CALCI Consortium Responses to Questions on Calibration

June 5, 2020
CALCI Scope Review Workshop

Responses to Committee Questions

"No FC opening" case.

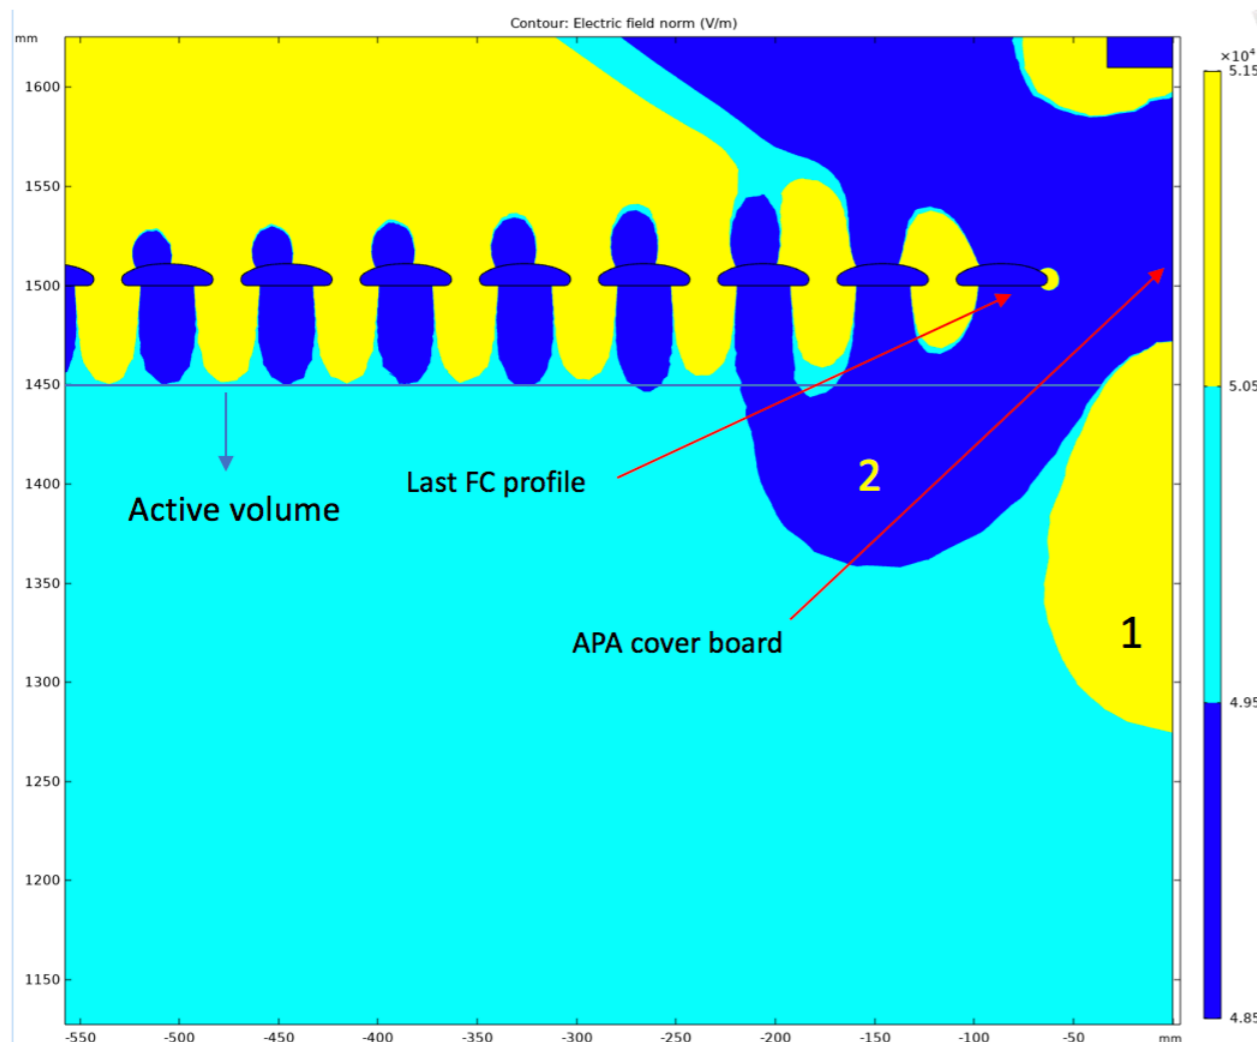
Q5. Based on Bo's electric field map of the active volume surrounding the laser penetration field cage opening, please specify the boundaries of the region within this active volume with $>1\%$ shifts in the electric field relative to nominal.

- Even without any FC opening, due to the larger gaps between APA and the first FC profile of the top and bottom FC modules, there are $>1\%$ distortions seen within the active volume (AV). This extends to ~ 20 cm in X and ~ 15 cm in Y into the AV.
- Because these distortions are present across the full length of the TPC, **the total active volume impacted is of the order of 10 m^3 (0.1% of 10^4 m^3).**

Distortions due to the larger gap b/n APA and the first FC profile. Cyan region is $< 1\%$, Blue and yellow are $> 1\%$ effects (same definition holds for all figures below).

Illustration of pin diode pads hanging from the FC support beams

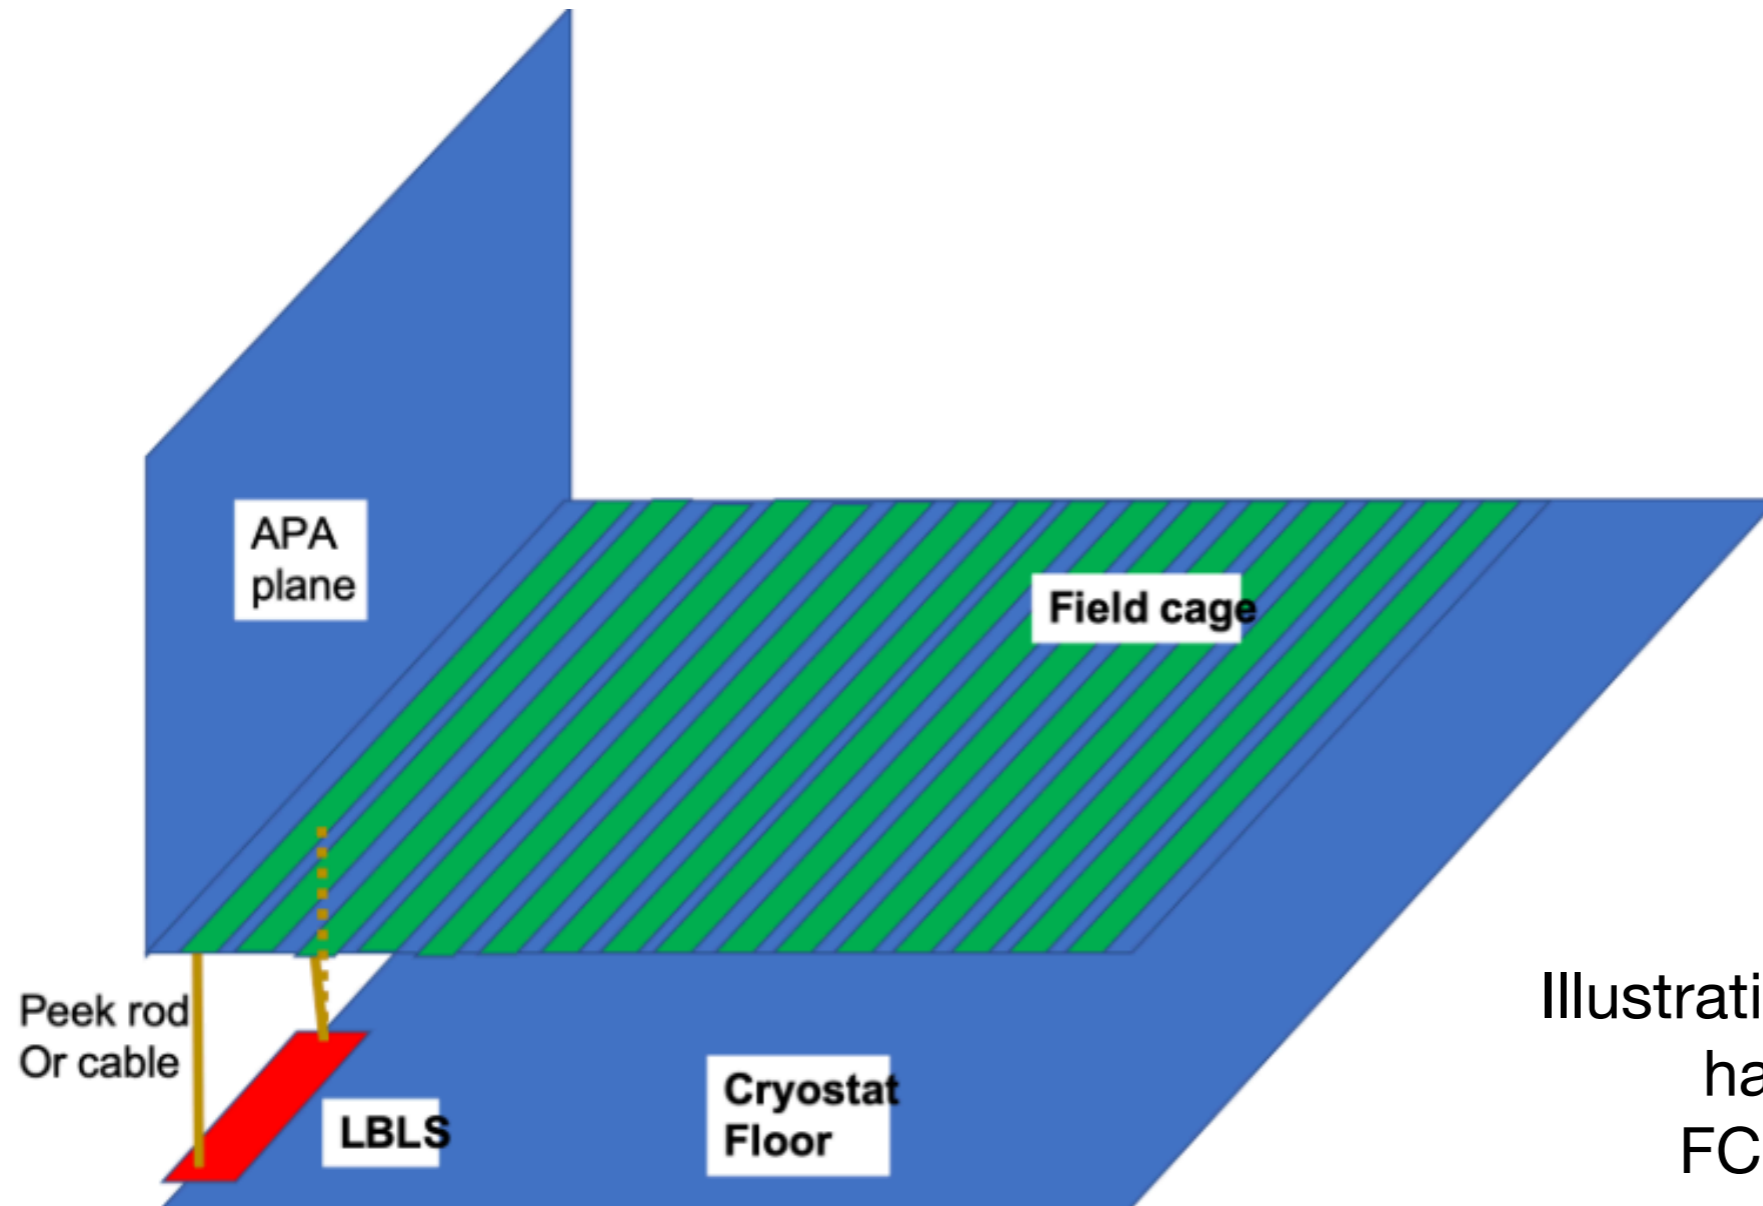
Q1. The TPC will move relative to the cryostat during the cool-down process. How can measurements made at the pin diode sensors be used to calibrate the position of a laser track relative to the TPC based on survey measurements of the pin diode pad locations relative to the APAs and CPAs made in the warm?

- Both pin diode system and laser periscope are in the cryostat reference frame
- Mirror pads are on the FC reference frame
- Combination of the data obtained with the mirror system and with the pin diode system can better pinpoint localization of the laser periscope during the actual cool-down.
- Alternatively, one can consider two options
 - hang the LBLS PIN diode pads at the floor level from the FC supports (possibly I-beams). (*see figure on next slide*). This way the diodes remain at the floor level (far from FC), but follow the motion of the FC, retaining consistency between survey measurements in warm and actual positions in cold.
 - Hang some of the PIN diode pads from the FC supports (TPC frame) and some glued to the cryostat floor

Magenta: central diode
Green, Blue: outer diodes

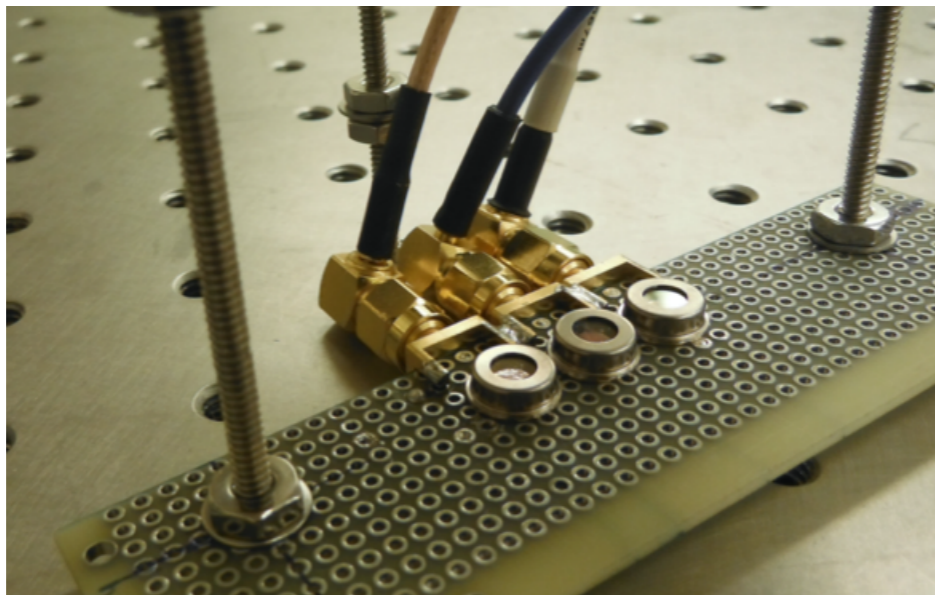
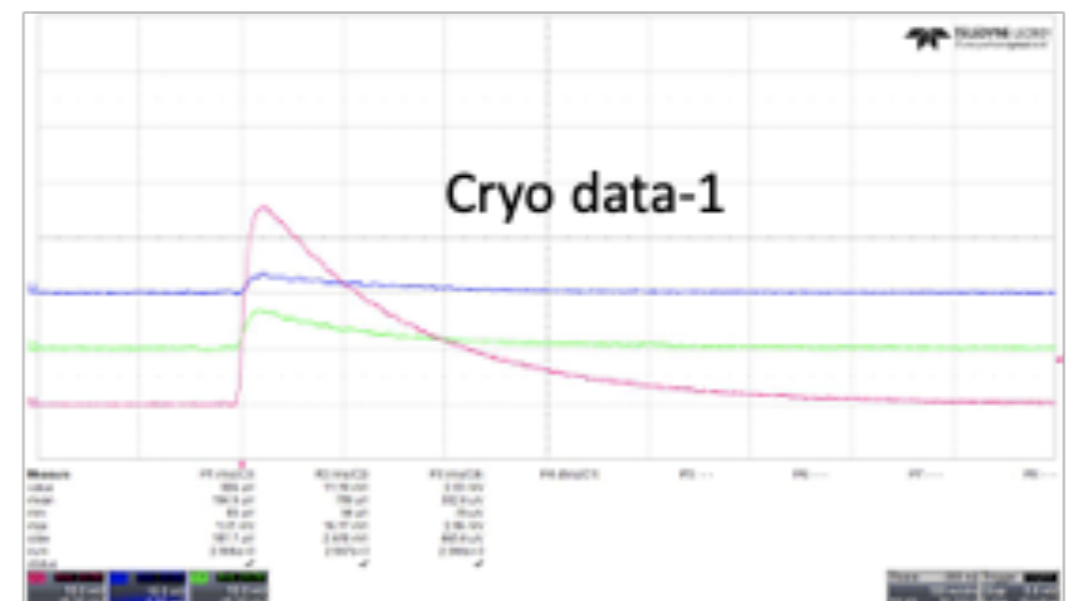
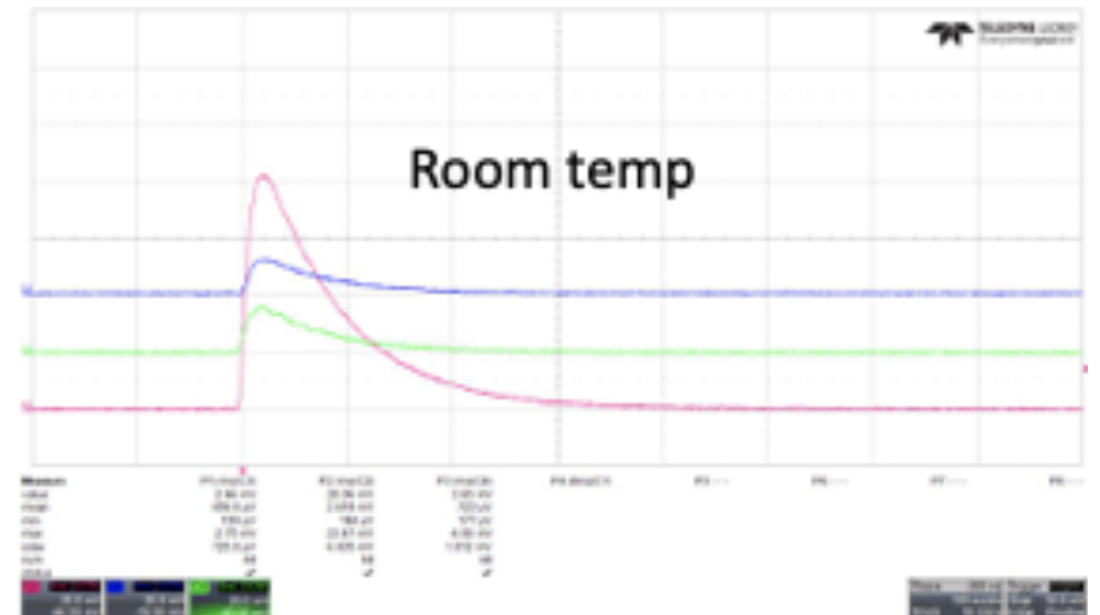
Q3. Do the pin diode sensors provide pulse height information that would be potentially useful for tuning and monitoring the laser intensity?

- Yes, the PIN diode sensors provide pulse height information and can be used for tuning and monitoring laser intensity.
- 3 pin diodes illuminated by 266 nm NdYag laser
- Different signal heights from the three adjacent illuminated PIN diodes allow for reconstruction of the center of the beam spot by looking for the peak weighted average center of the signal.
- Signal features fast rise time

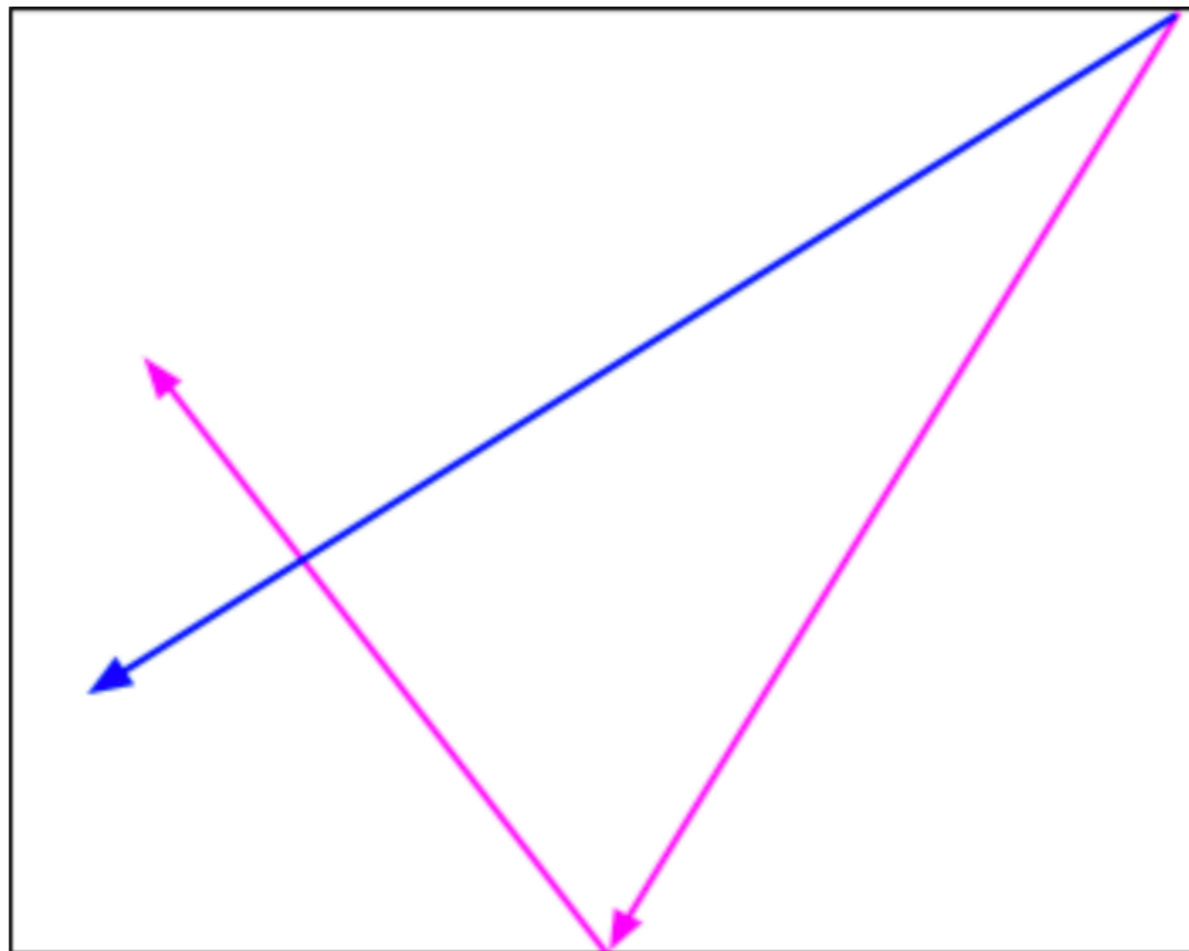
Q4. Do the mirrors play a role in increasing the overall laser coverage?
Could the mirrors play the role in creating additional tracks to help resolve ambiguities?

- Yes, but in practice that increase in coverage would be very small.
- It is true that a single laser periscope can create tracks of different angles in the same region. As an example, in the next figure the blue and second magenta lines have different angles and can cross even if they are coming from the same laser.

The requirement on the straightness of the FC profiles would be very stringent. A small tilt of 0.1 deg on the profiles causes a 1cm beam deviation at 6 m from the mirror.

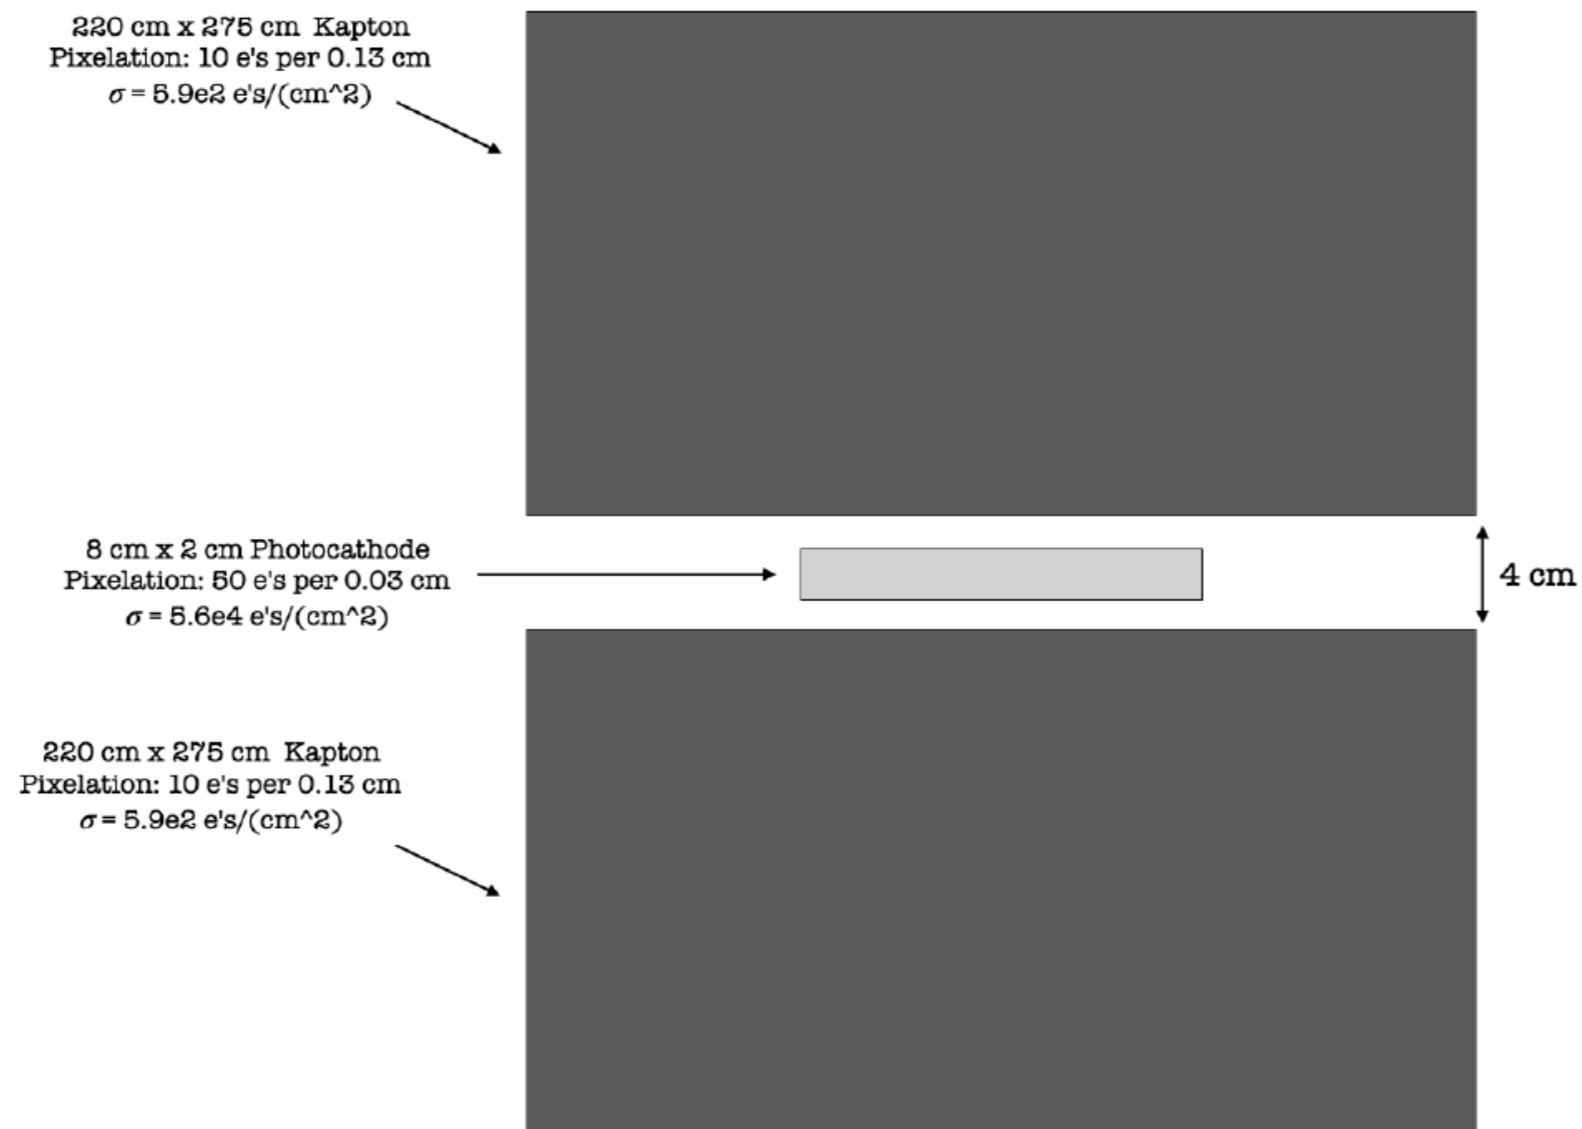
Q5. On slide 20 of Jelena's presentation, it indicates that a 5m illumination diameter is anticipated. Is this from a single fiber? This would be about the correct size to illuminate the entire cathode plane surface parallel to a single APA. Should we be concerned that the resulting emission of electrons from all of the targets and brass connectors will produce a signal in every readout channel of the APA making it impossible to identify the electrons associated with specific targets? For a diameter this large, how non-uniform is the light over the illuminated area and does the non-uniformity remain consistent pulse to pulse?

Carried out simulation studies of photoelectric effect in Kapton and how to observe the reconstructed signal from photoelectric targets on top of Kapton.

Studies exemplify how we can distinguish targets on top of Kapton signal, based on their collection and induction wire signals.
